# Access Compliance Report

## Public Rights-of-Way

Intersection ID: 11686	Main Street: BRISTOL_DR	Cross Street: CARLYLE_DR	Location: SE
ADA ID: 533364C32323	Ramp Type: Perp	Initial Pass/Fail: Fail	Overall Compliance: No
		Severity Score: 10

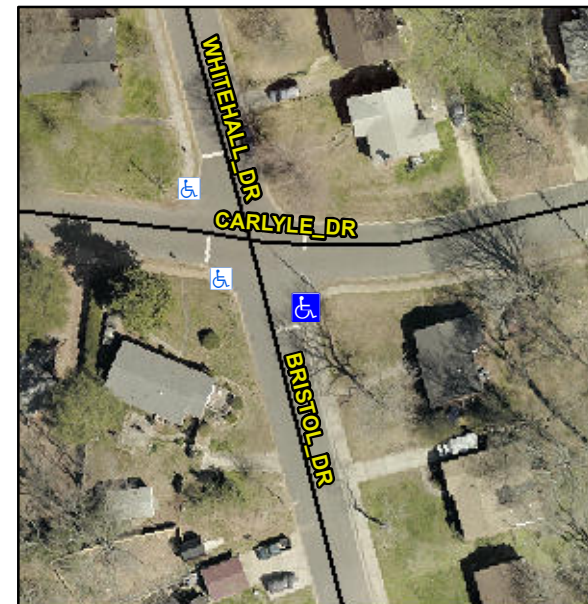
**Not Found, R304.5.1, R304.5.3**

Compliance	Description	Data	Compliance	Description	Data
N/A	Ramp Length (in)	73.0	Yes	Ramp Slope (%)	6.8
No	Ramp Width (in)	47.0	No	Ramp XSlope (%)	3.2
N/A	Flare Type LT	N/A	N/A	Flare Type RT	N/A
N/A	Flare Slope LT (%)	N/A	N/A	Flare Slope RT (%)	N/A
N/A	Flare Traversable LT?	N/A	N/A	Flare Traversable RT?	N/A
N/A	Landing Length (in)	N/A	N/A	DWS Provided?	N/A
N/A	Landing Width (in)	N/A	N/A	DWS Contrast?	N/A
N/A	Landing Slope (%)	N/A	N/A	DWS Length (in)	N/A
N/A	Landing X Slope (%)	N/A	N/A	DWS Full Width?	N/A
N/A	Landing Curb? (Y/N)	N/A	N/A	DWS Offset (in)	N/A
N/A	Shared Landing?	N/A			
N/A	Gutter Ponding?	N/A	N/A	Gutter Slope (%)	N/A
N/A	Gutter Lip Ht (in)	N/A	N/A	Gutter X Slope (%)	N/A
N/A	Painted X Walk1?	No	N/A	Painted X Walk2?	N/A
	X Walk 1 Direction	To NW		X Walk 2 Direction	N/A
N/A	X Walk 1 Width (in)	N/A	N/A	X Walk 2 Width (in)	N/A
	X Walk 1 Slope (%)	3.9		X Walk 2 Slope (%)	N/A
	X Walk 1 X Slope (%)	4.3		X Walk 2 X Slope (%)	N/A

**Remove & Replace Entire Ramp.**
